SUNDRY NOTICES AND REPORTS ON WELLS

2. Name of Operator Agave Energy Company

AGAVE RED HILLS AGI #1 PROPOSED WELLBORE

CONDITIONS OF APPROVAL

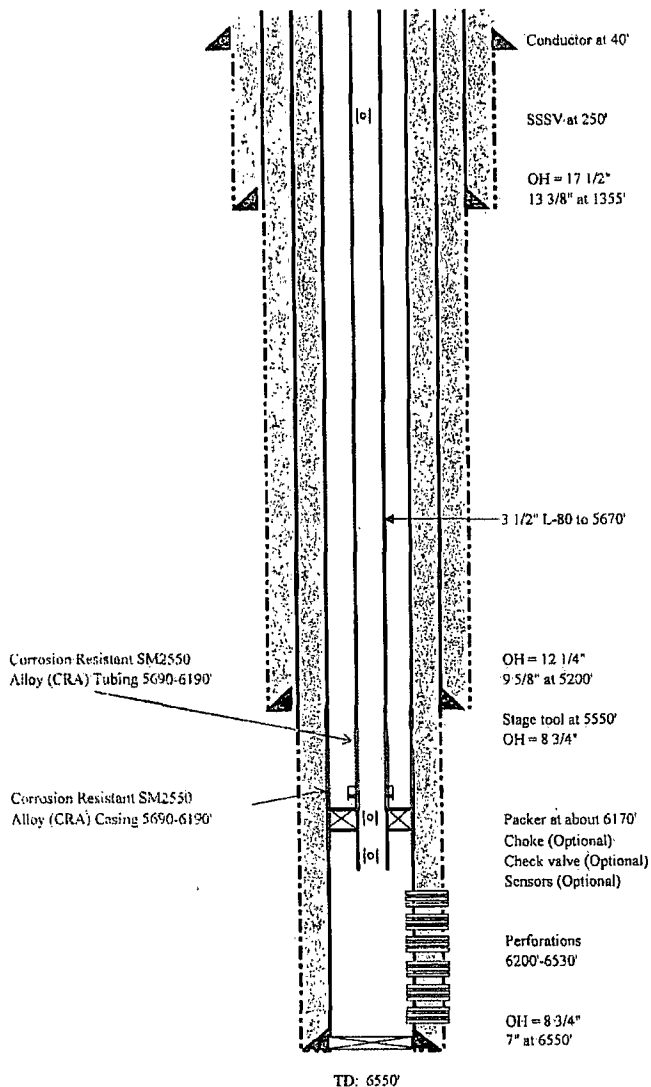
The operator wishes to revise the well casing design to optimize drilling process and to upgrade the overall corrosion resistance of the approved design. All other aspects of the APD which was approved on 2/13/2012 will remain the same. The casing design for the well has been modified as per the attached wellbore diagram. The casing integrity calculations and the cementing modifications have also been revised and the revised portions of the approved 9 point drilling plan are also attached. We would not propose any other changes to the approved APD or the associated COA.

The primary change from the approved design is a change in the previous casing design to reduce the diameter of the four casing strings from 26"/20"/13-3/8"/7" to a 20"/13-3/8"/9-5/8"/7" design. This is accompanied by an enhanced section of corrosion resistant (SM2550) steel casing in the production string and in the bottom 500' of the tubing as shown on the attached wellbore diagram. This change resulted in the need to redo the casing integrity calculations and to revise the cement quantities and staging based on the revised wellbore design. The proposed changes to Sections IV and V of the approved nine point drilling plan are detailed in the attached revised pages which should substitute for the same pages in the approved drilling plan and COA. No other changes are proposed or required and the operator agrees to remain bound by all other approved requirements of the APD and COA.

Changes to the approved APD casing program need prior approval if the items substituted are of lesser grade or different casing size. The Operator can exchange the components of the proposal with that of superior strength (i.e. changing from J-55 to N-80, or from 36# to 40#). Changes to the approved cement program need prior approval if the altered cement plan has less volume or strength or if the changes are substantial (i.e. Multistage tool, ECP, etc.).

1. The **13-3/8** inch surface casing shall be set at approximately **1355** feet in a **competent bed below the Magenta Dolomite, a Member of the Rustler**, and if salt is encountered, set casing at least 25 feet above the salt and cemented to the surface. **Freshwater mud to be used to setting depth.**

2. The minimum required fill of cement behind the **9-5/8"** inch intermediate casing is:
 - ☒ Cement to surface. If cement does not circulate see B.1.a, c-d above. **Wait on cement (WOC) time for a primary cement job is to include the lead cement slurry due to acid gas injection.**
Additional cement shall be required as excess cement calculates to 20%.

3. The minimum required fill of cement behind the **7 inch production casing** is:

a. **First stage using 15 ppg acid resistant CORROSACEM cement:**

- ☒ Cement to circulate. If cement does not circulate, contact the appropriate BLM office before proceeding with second stage cement job. Operator should have plans as to how they will achieve circulation on the next stage.
Additional cement may be required as excess cement calculates to 15%.

b. Second stage above DV tool:

- ☒ Cement to surface. If cement does not circulate, contact the appropriate BLM office. **Wait on cement (WOC) time for a primary cement job is to include the lead cement slurry due to acid gas injection. Additional cement will be required, as excess cement calculates to a negative 18%**

Operator shall run a circumferential cement bond log for the 7" production casing. The log shall be capable of providing casing condition baseline, such as a Corrosion Evaluation log. The log is to be calibrated for the hole, with the calibration strip to be clearly labeled and included with the final print and digital data file. Any identified anomalies in cement bond quality are to be discussed with BLM before proceeding.
